## Access Compliance Report Public Rights-of-Way (Curb Ramps)

Intersection ID: 44069 Main Street: WESTMILL\_LN Cross Street: KIRKWICH\_CT Location: E

ADA ID: 2E0EEFDB0A39 Ramp Type: BlendTrans1 Initial Pass/Fail: Fail Overall Compliance: No Severity Score: 18.75

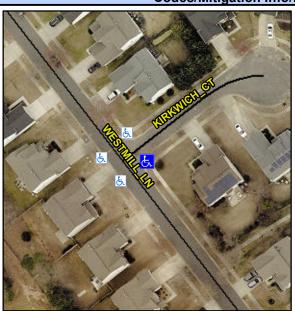
DAMAGED CURB/GTR

Not Found, R304.5.1, R304.5.3

Remove & Replace Curb Ramp With Two New Directional Ramps or Equivalent.
